CONCEPTUAL DESIGN

144 CHARLES STREET

RELATED BEAL
DEVELOPER + GENERAL CONTRACTOR

HACIN + ASSOCIATES
ARCHITECT

PROPOSED BUILDING ELEVATIONS

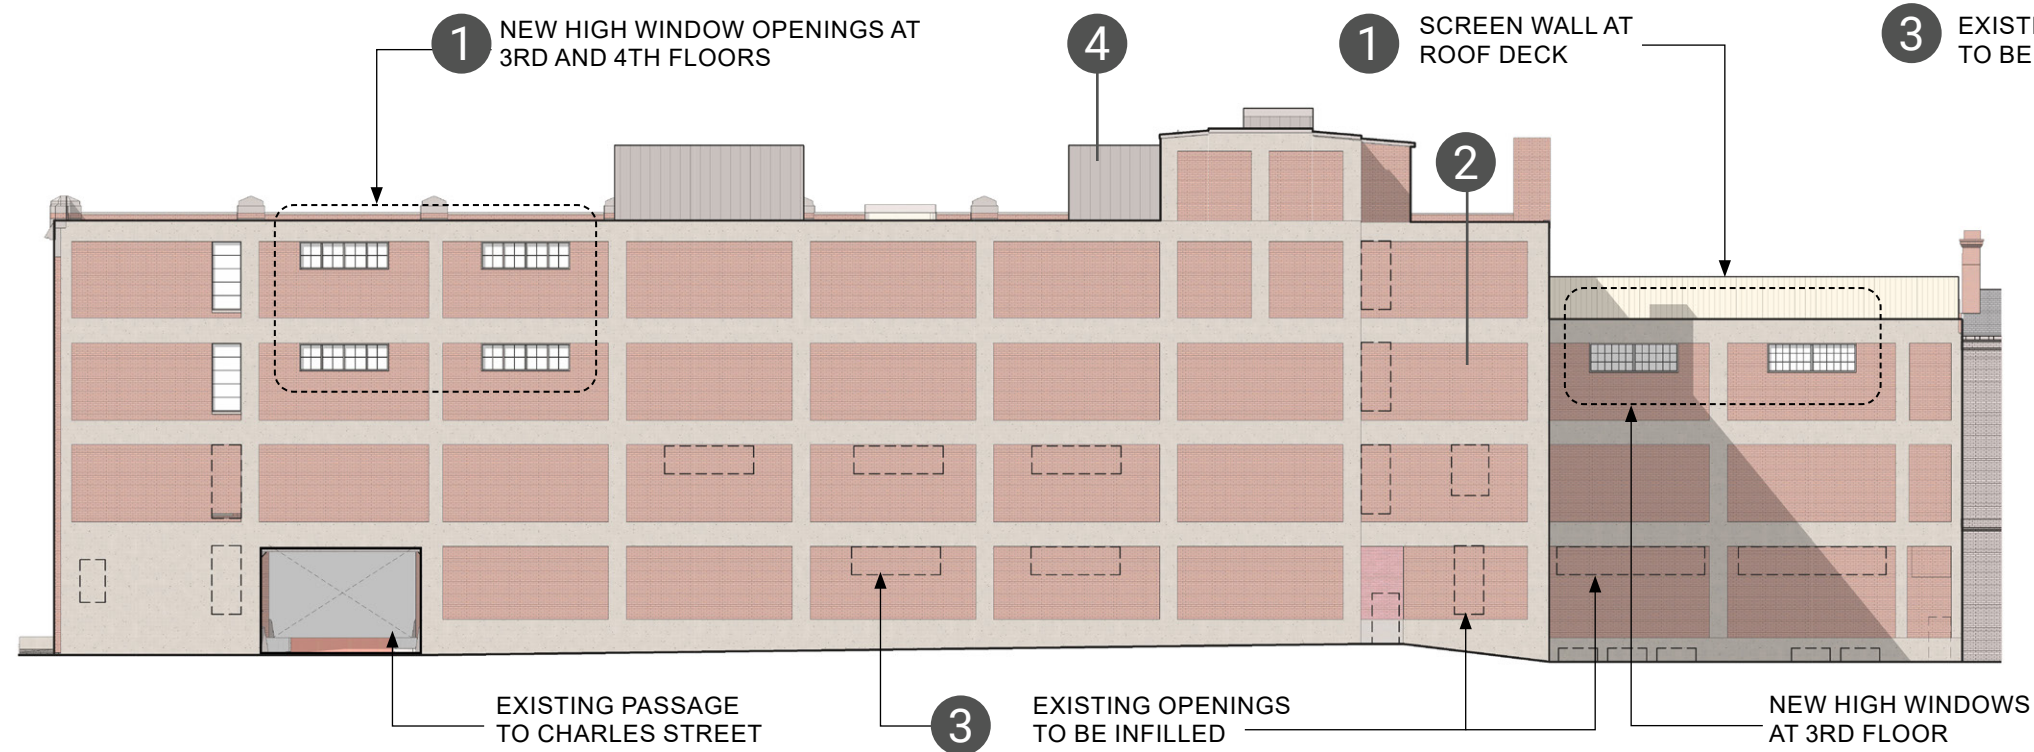
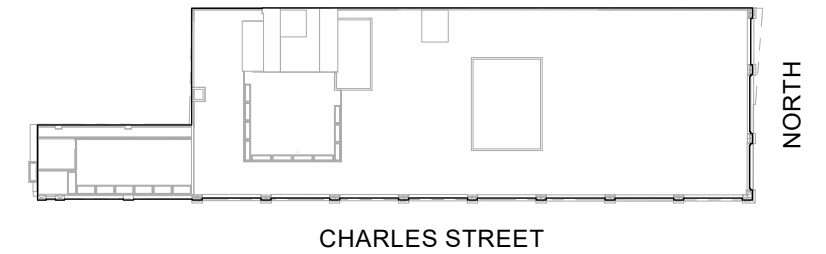
1. Questions regarding security, lighting, appropriate finish materials, and access within the existing passage.
2. Interest in reducing reflectivity and light pollution from windows facing Charles Street.
3. Questions over precedent of new openings visible from the public way.
4. Desire to understand the amount of roof deck visibility from Charles Street.

1. New contextually appropriate brick pavers, finished ceiling, and lighting to be added to enhance the existing passage and improve safety.
2. Studying the condition and performance of existing windows. Any proposed modifications will be reviewed through Beacon Hill Architectural Commission.
3. Proportion of new windows correlate with existing windows at North, South, and Charles Street facades. Proposed modifications will be reviewed through Beacon Hill Architectural Commission.
4. Roof decks set back from parapet walls. Perimeter planters and a decorative screen will minimize visibility of occupants and activity.

PROPOSED BUILDING ELEVATIONS

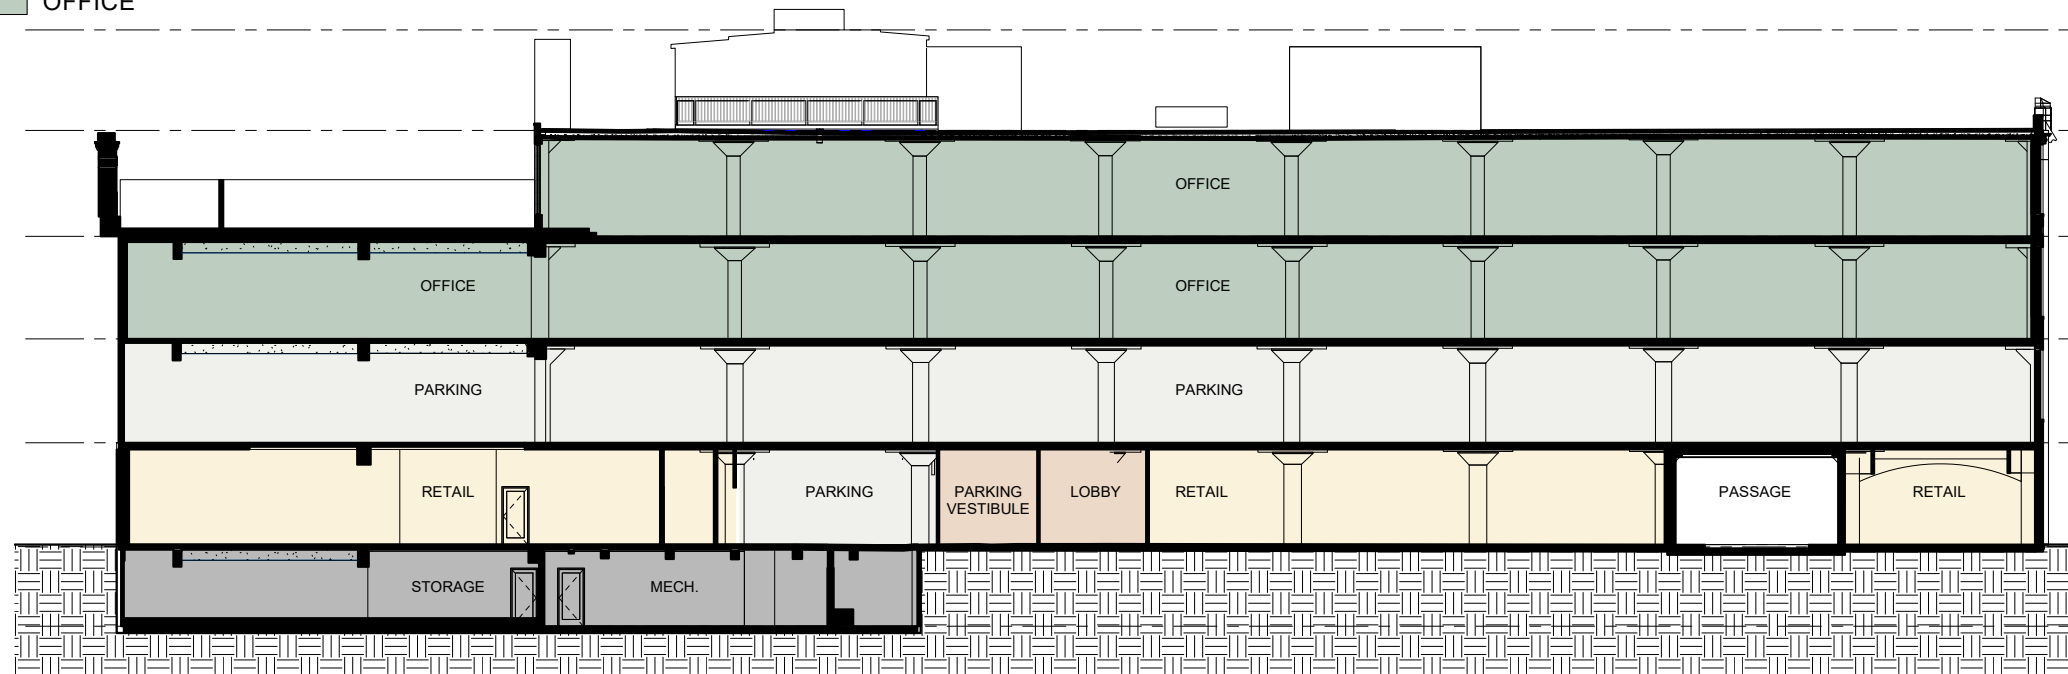
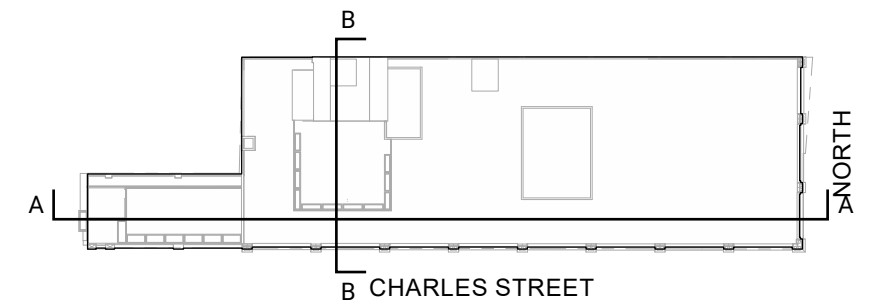
1. Request to screen view of office users from abutting neighbors and from Annie Fields Garden to protect privacy and avoid light pollution.
2. Request to protect and restore green wall, and remove invasive trees.
3. Clarify which existing window openings are to be infilled.
4. Desire to understand sound levels from rooftop mechanical equipment.

1. Proposed windows are approximately 8' above the floor to provide the office space with light, while shielding views in and out with obscured glass. A screen wall along the 4th floor roof deck will minimize view of activity from abutting neighbors.
2. Studying required repair of masonry wall to understand impact on existing green. Care will be taken to protect view and experience within Annie Fields Garden.
3. Dashed lines in Elevations indicate existing openings to be infilled.
4. Acoustic consultant to be engaged to advise on enclosure construction for sound attenuation, similar to at Whitney Hotel.

INITIAL CONCEPT FIRST FLOOR PLAN (01/20/2021)

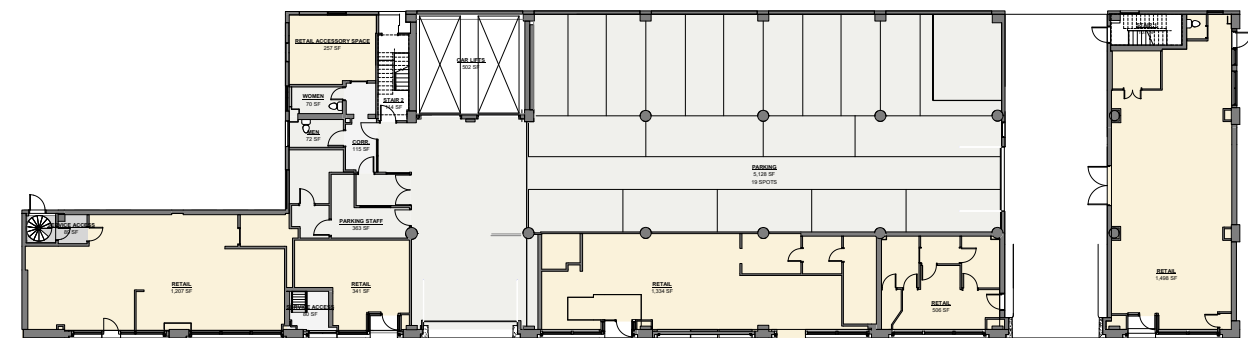
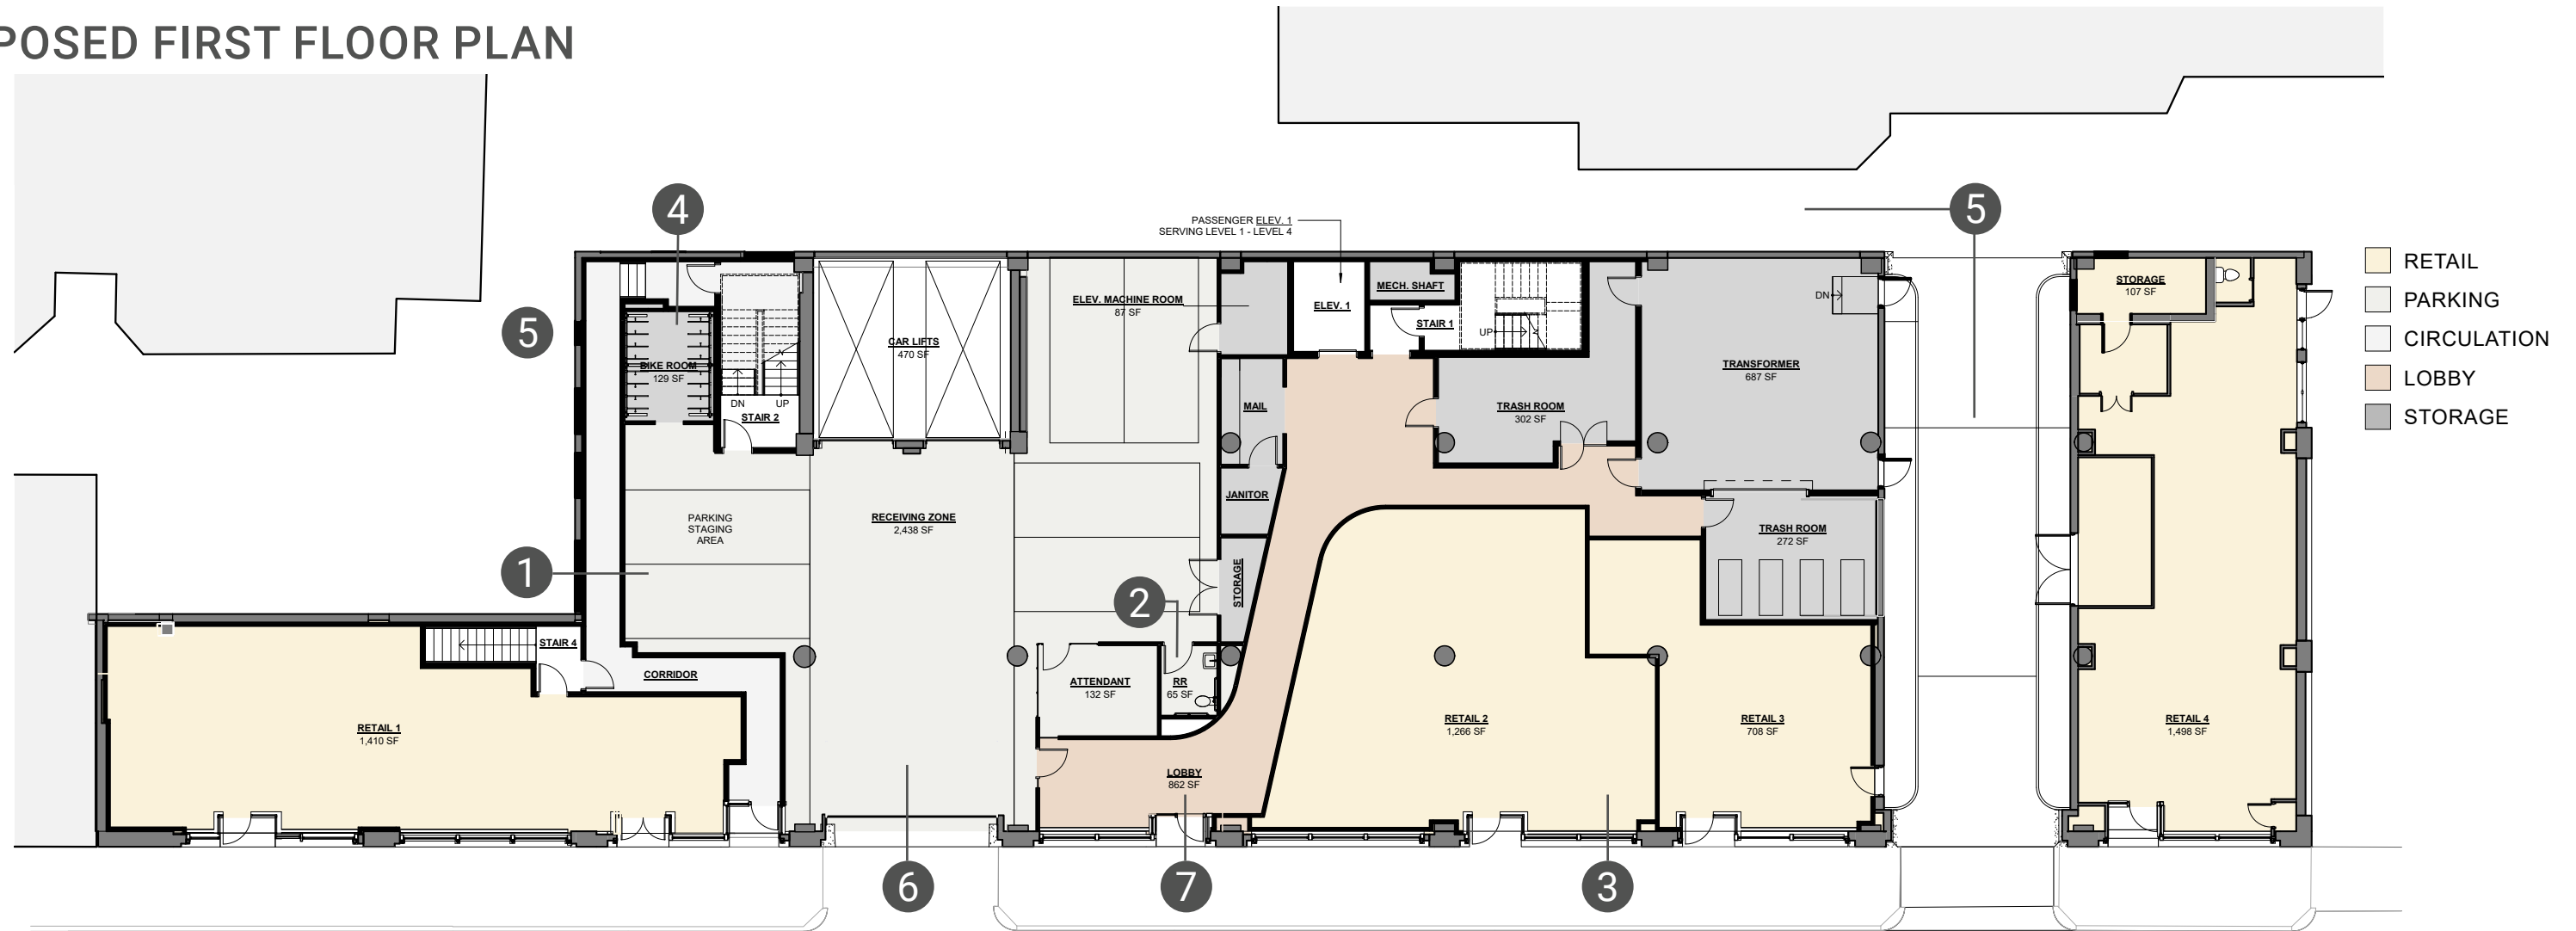
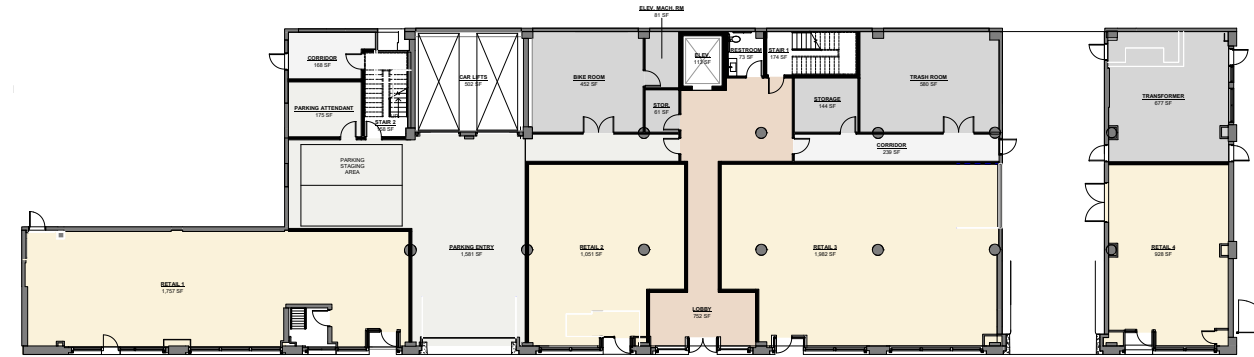
1. The two staging spaces are insufficient and too small.
2. No public restroom.
3. Expanded retail spaces inappropriate for neighborhood.
4. Bike room too large.
5. Security concern in passage and along alleyways between residences and the garage.
6. Desire to understand vehicle queuing, circulation, and general garage operations.
7. Lobby scale is not in keeping with the scale and character of Charles Street.

1. Increased number of staging spaces to 6 and enlarged parking receiving area, per analysis by traffic engineer.
2. Public restroom accessible to parking garage users.
3. Smaller scale retail spaces appropriate for the neighborhood.
4. Relocated bike room.
5. Enhanced lighting and security cameras to be installed.
6. Traffic engineer has analyzed and verified functionality. Refer to following slides for parking data.
7. The lobby entrance is relocated to utilize an existing entry door and developed to serve essential functions, including serving as a waiting area for the parking garage. Curved lobby walls and selected finish materials will reflect the quality expected of Charles Street and Beacon Hill.

INITIAL CONCEPT (01/20/2021) AND PROPOSED SECOND FLOOR PLAN

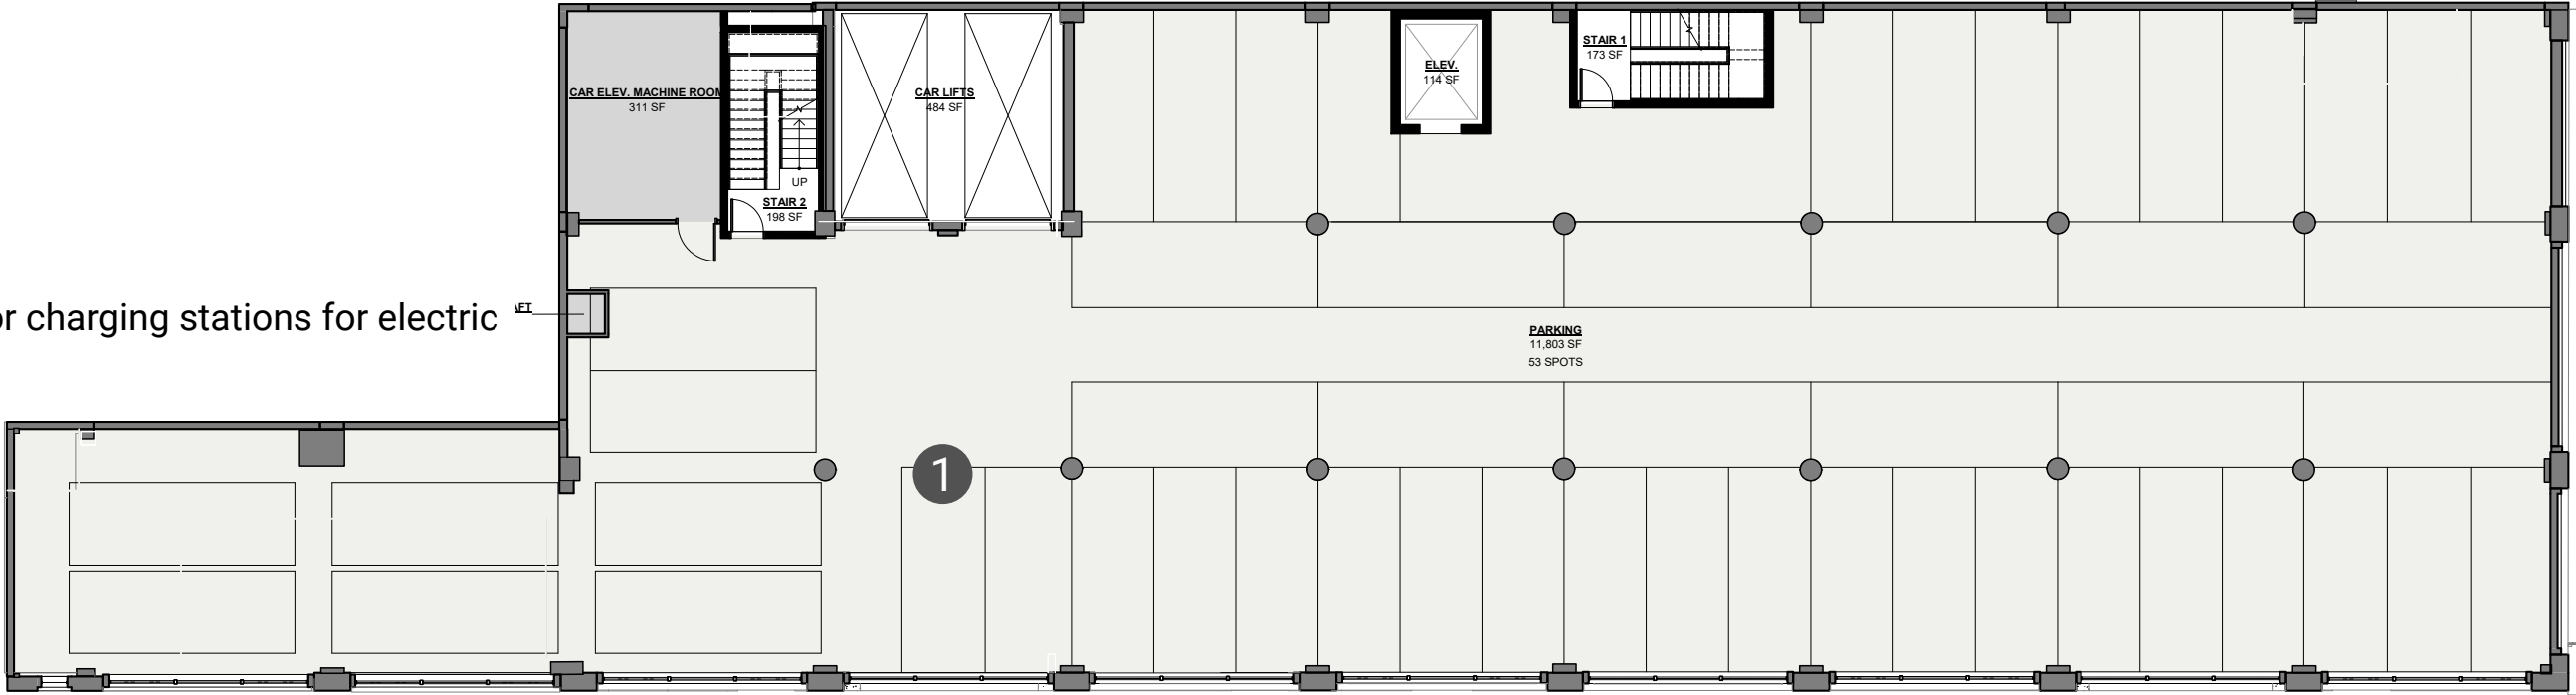
- 1. Request for charging stations for electric vehicles.

- 1. Four charging stations added for electric vehicles.
